**CITY OF FORT COLLINS
TYPE 1 ADMINISTRATIVE HEARING**

FINDINGS AND DECISION

PROJECT NAME: Kechter Farm Mixed Use Townhomes

CASE NUMBER: PDP # 210006

Below is a screen shot cropped and combined from the landscape plan submittal sheets.

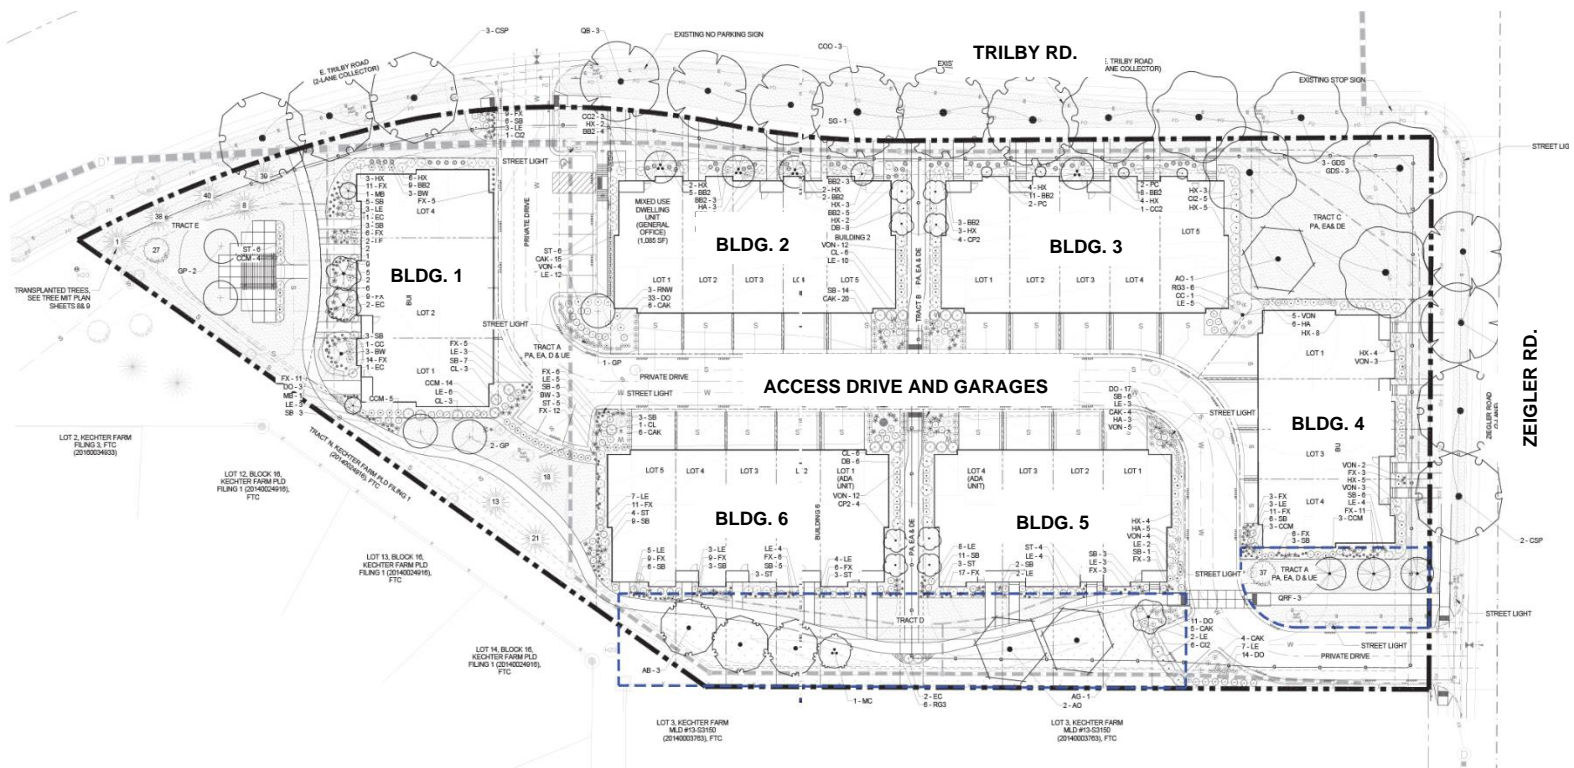
- Buildings are 2-story and arranged 4- and 5-plexes, with one of the 5-plexes also containing a 1,085 square foot office commercial space to meet a requirement for mixed use. The mixed-use building is required because the site is designated for 'neighborhood center' commercial use in the approved Kechter Farm Filing 1 development plan to meet requirements for a neighborhood center for Kechter Farm.

- Parking exceeds minimum requirements.
- The site is 2.66 acres, with a proposed residential density of 10.15 dwelling units per acre.
- Two modifications of standards are required. One is to allow two different building designs rather than three as the standard requirement. The other is to allow two buildings that are not placed in direct orientation to a street, but rather face a walkway that crosses an entry drive and is 367 feet in length from the street to one of the front doors of a home in building 6.

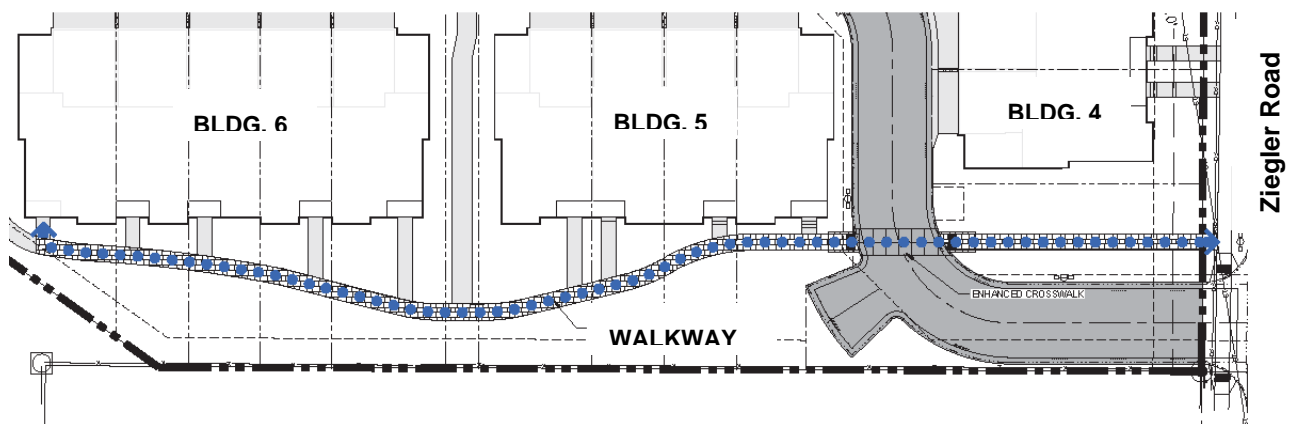
The image below compares the 4-plex (top) and the 5-plex (bottom). One aspect that is not indicated in the image is that the masonry base of the 5-plex has been revised to be stone, and the entry doors will be different in the two building designs.

The 4 plex and 5-plex offer a degree of subtle variation in the size and footprint and differences in the masonry, with brick on the 4-plex and stone on the 5-plex.

Staff finds that the granting of the modification would not be detrimental to the public good and that the plan satisfies criterion (1), “equal or better” under Section 2.8.2(H) governing modification requests.

Detriment to the public good. The quality of the architecture of this cluster of buildings provides a high degree of visual interest and avoids monotonous repetition. It accomplishes the purpose of the standard with modulated building massing and roof forms within a coordinated and harmonious overall theme, articulated facades with textures in architectural materials, details within the theme, and varied orientation in building placement, such that the six-building group provides positive visual interest to the neighborhood.

Criterion (1), “equal or better”. Staff does not find that changing the design or materials among the buildings would add any visual interest better than the harmonious effect of the six-building group as proposed.

The variation and visual interest in the buildings accomplishes the purposes as well or better than a plan that complies because:
